**SUPPLEMENTAL BID BULLETIN**  
**ADDENDUM NO. 2023-004-02**

**Subject: Supply, Delivery, Installation, Testing, Training and Commissioning of the Automatic Weather Observing System (AWOS) at Mactan - Cebu International Airport and PAGASA Mactan Station**  
**(Reference: PR No. 2023-02-0090 / IB No. 2023-004)**

**AWOS DATA COMMUNICATION FLOW FROM RUNWAY 04 AND 22 TO PAGASA-MACTAN OFFICE AND TO CAAP CONTROL TOWER**

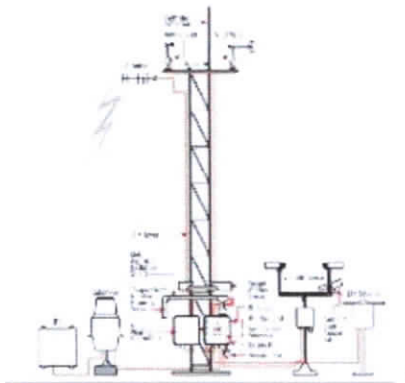
3. May we request a network diagram for the data communication and transmission	<p>Please see attached "<b>Annex A</b>"</p> <p>The basic flow of data communication is from Runway 04 and 22 sites respectively and send directly to PAGASA Mactan Office for processing. The process data from PAGASA-Mactan office can be viewed by the Control Tower personnel for monitoring and guidance. Your foreign counterpart who are expert in AWOS may have already familiar with this methodology.</p>

ANNEX A
